Public Works Department – Engineering Division

March 29, 2024

ADDENDUM NO. 1

PROJECT 8336 AMERICANA PARK BYPASS CHANNEL

As-Builts – 20” Waterline

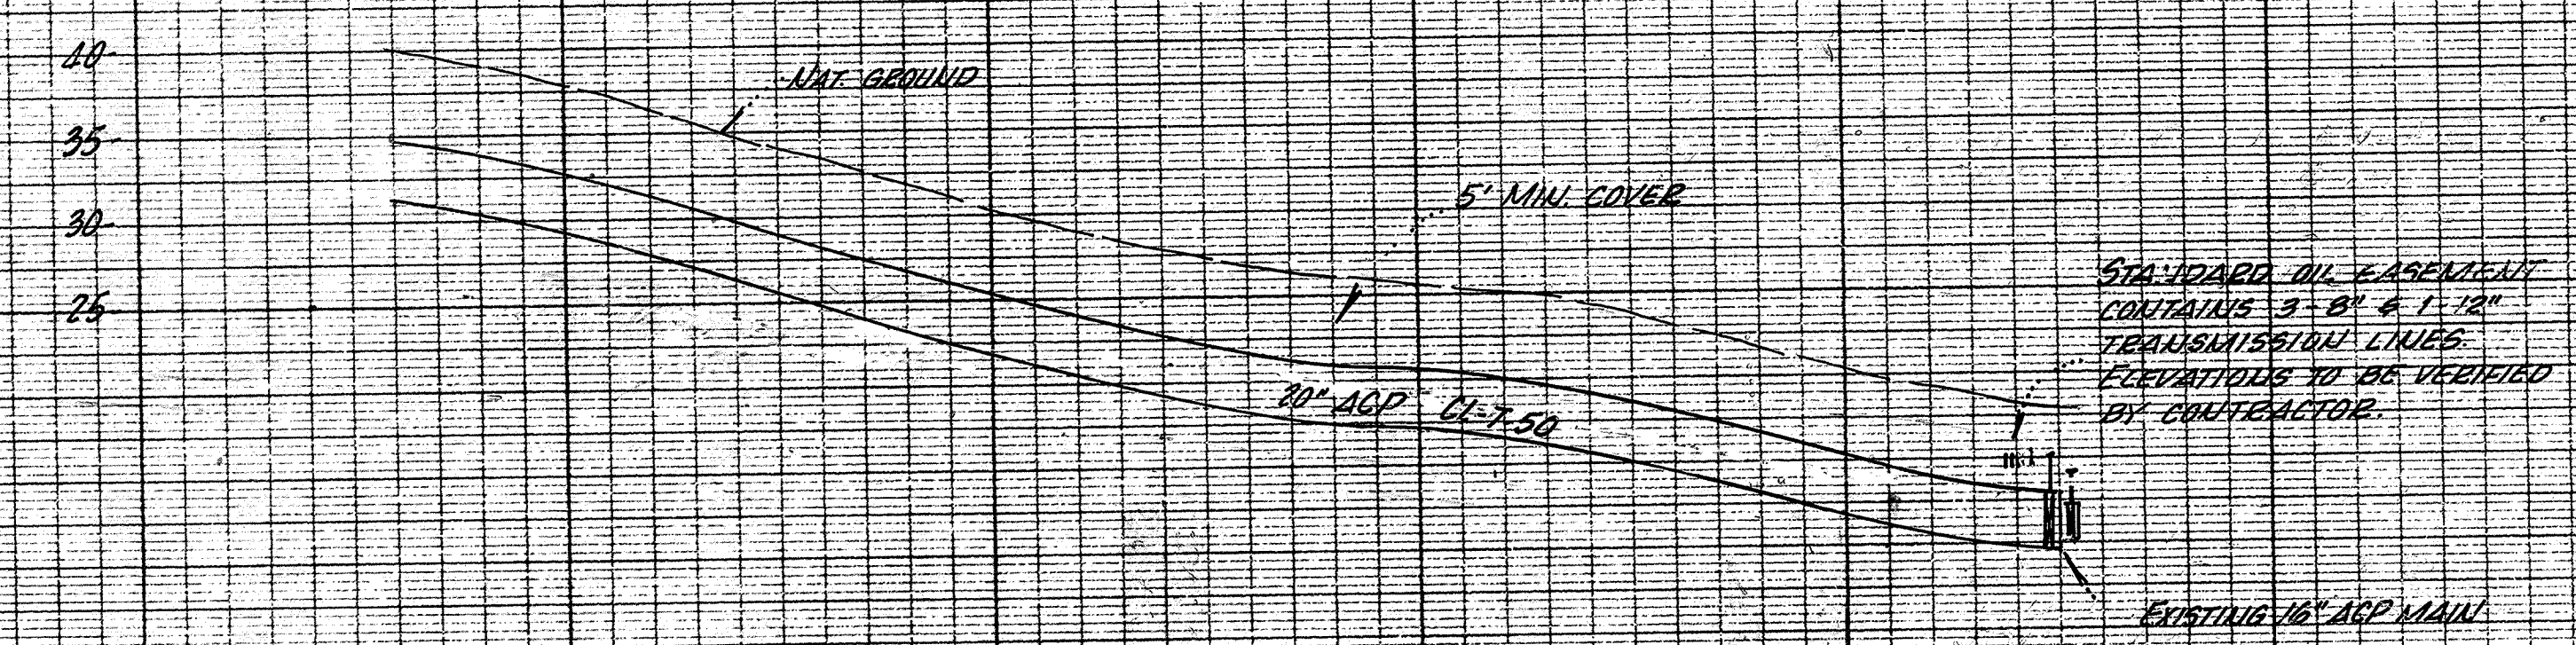
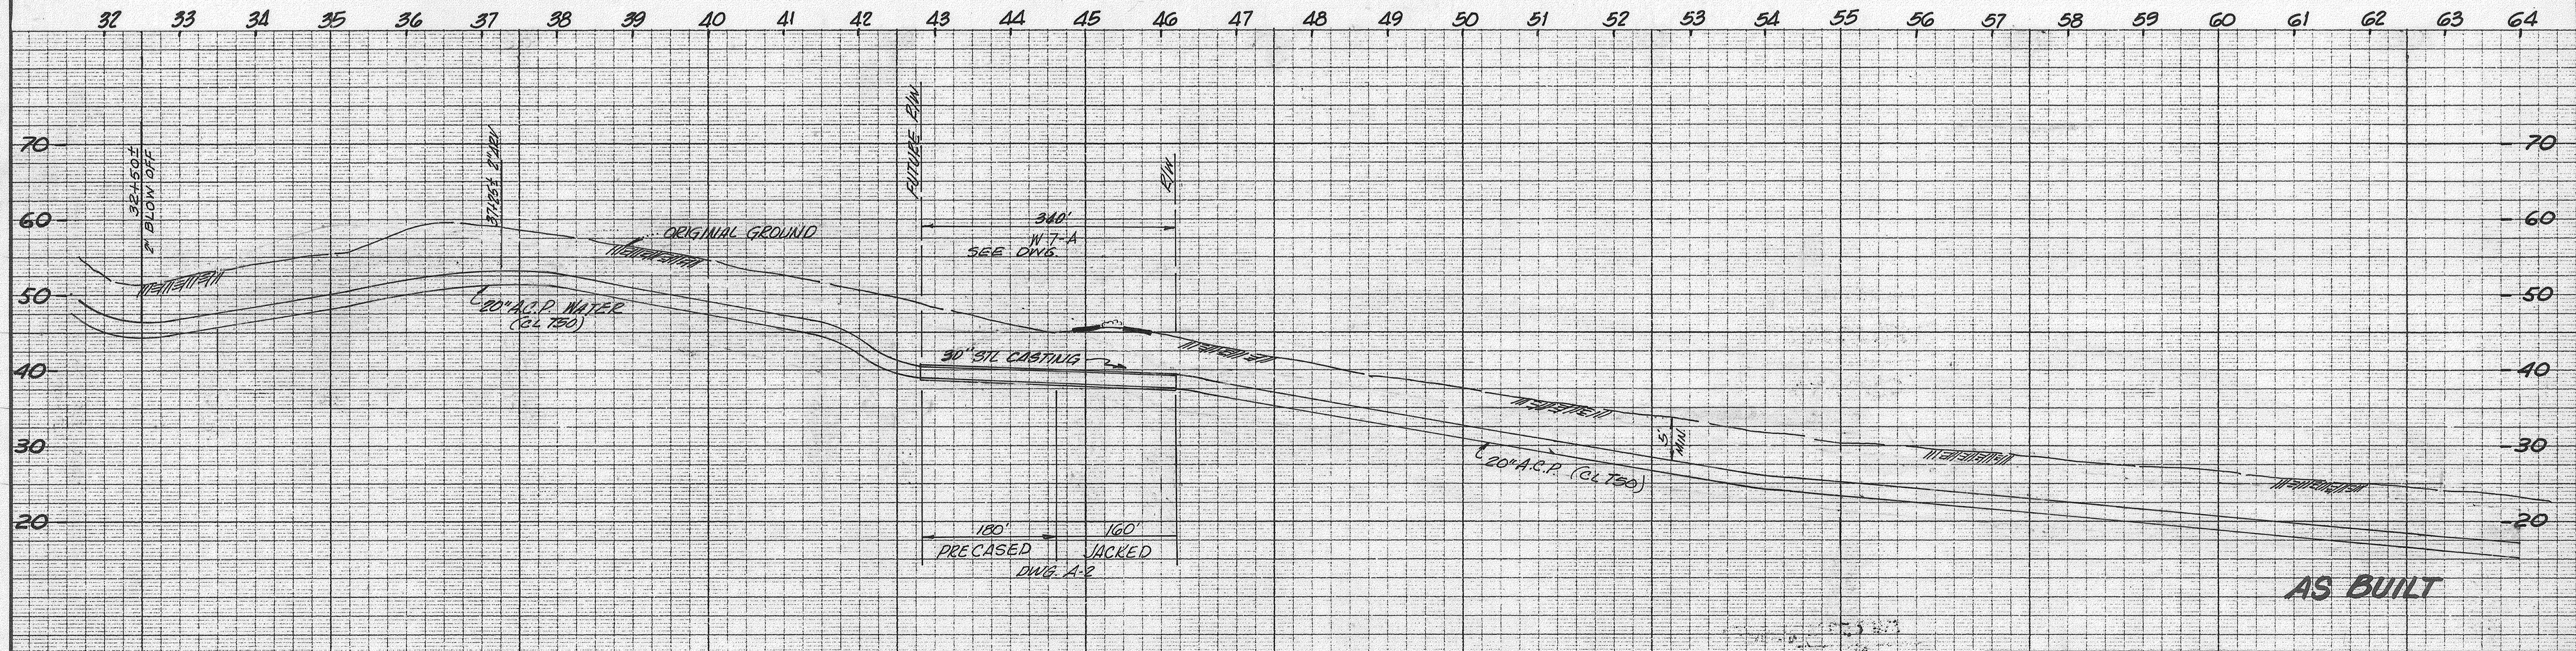
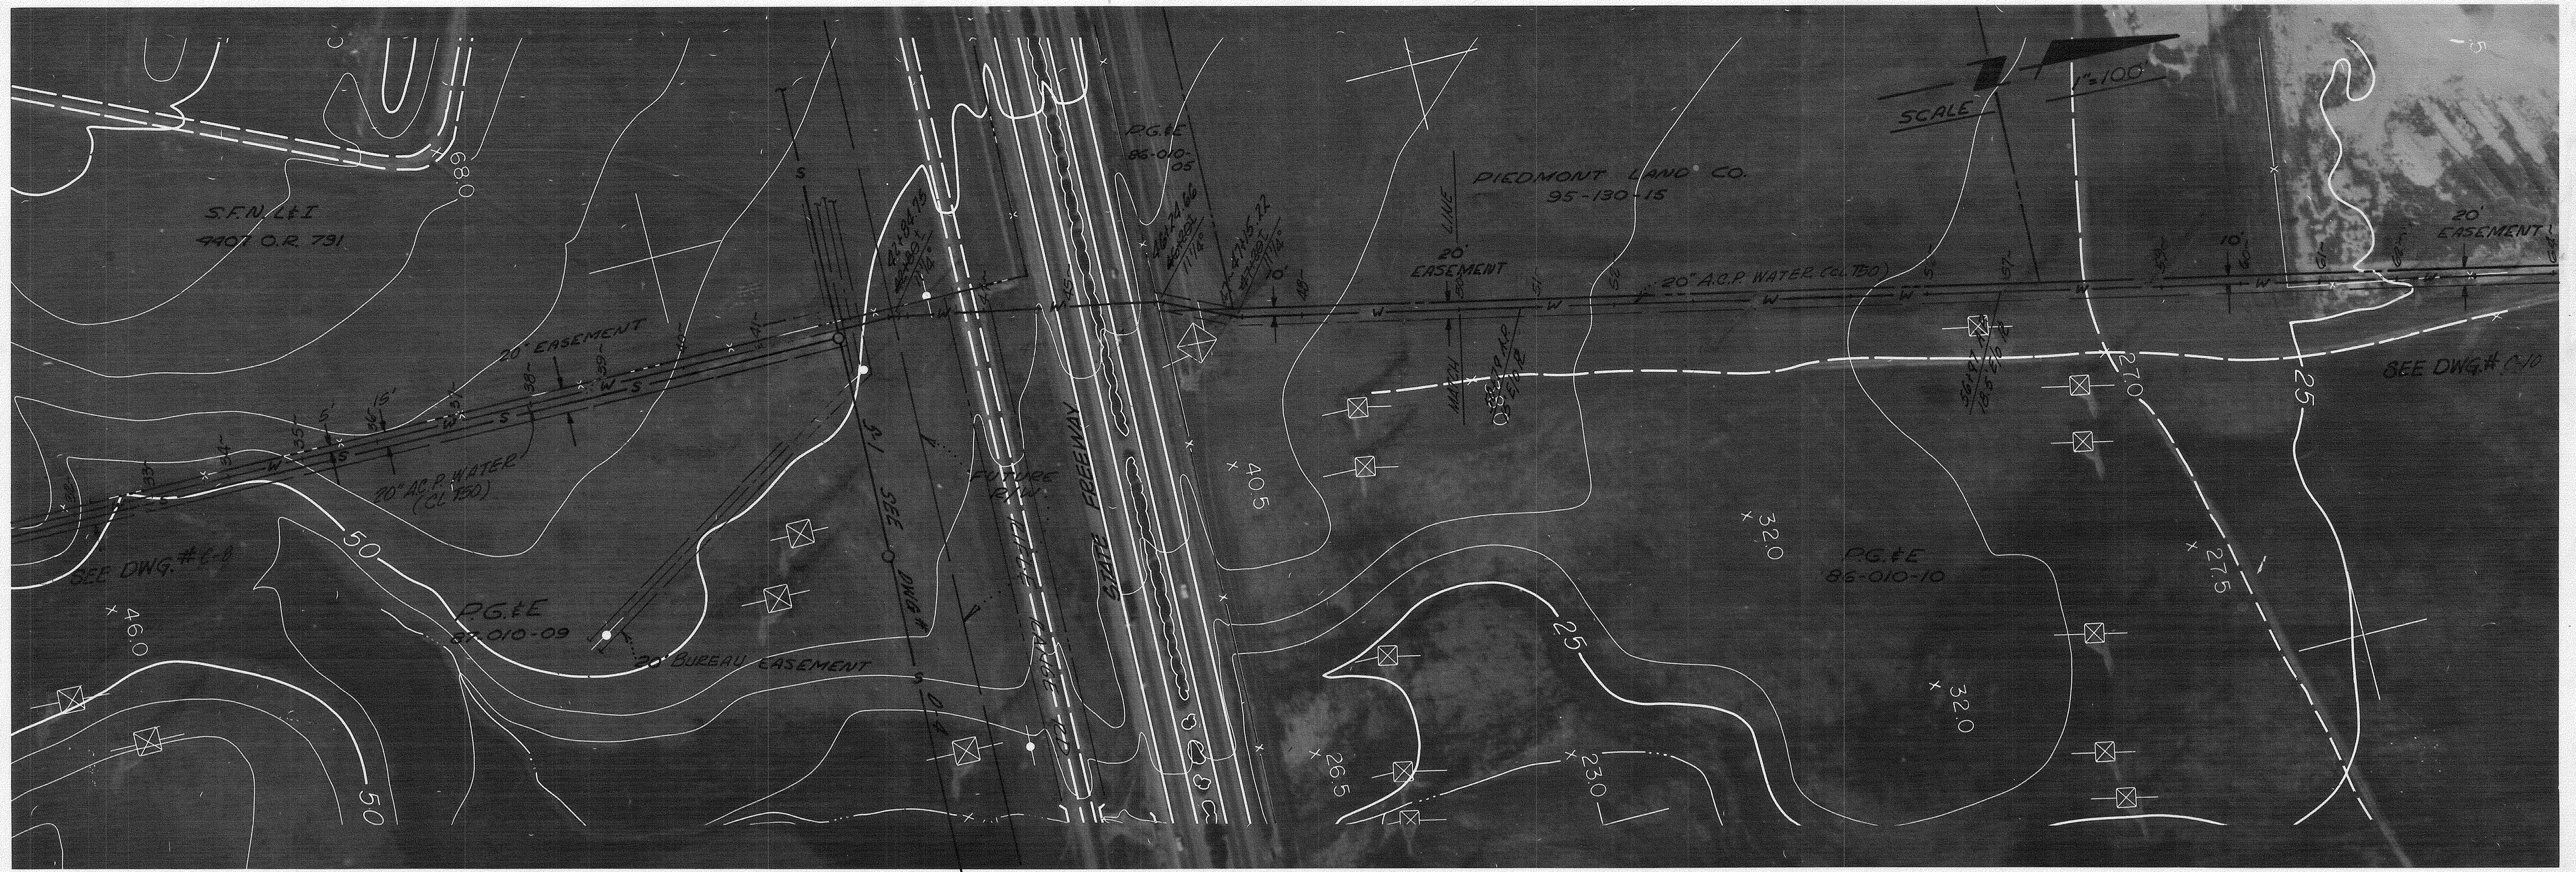
5. Please provide as-built drawings for the 15-inch and 20-inch water lines showing the location of the nearest existing isolation valves on both sides of the work area, if available.

Response: Attachment D has been attached for the 20-inch water line showing location of the nearest valves. The contractor shall pothole and confirm location.
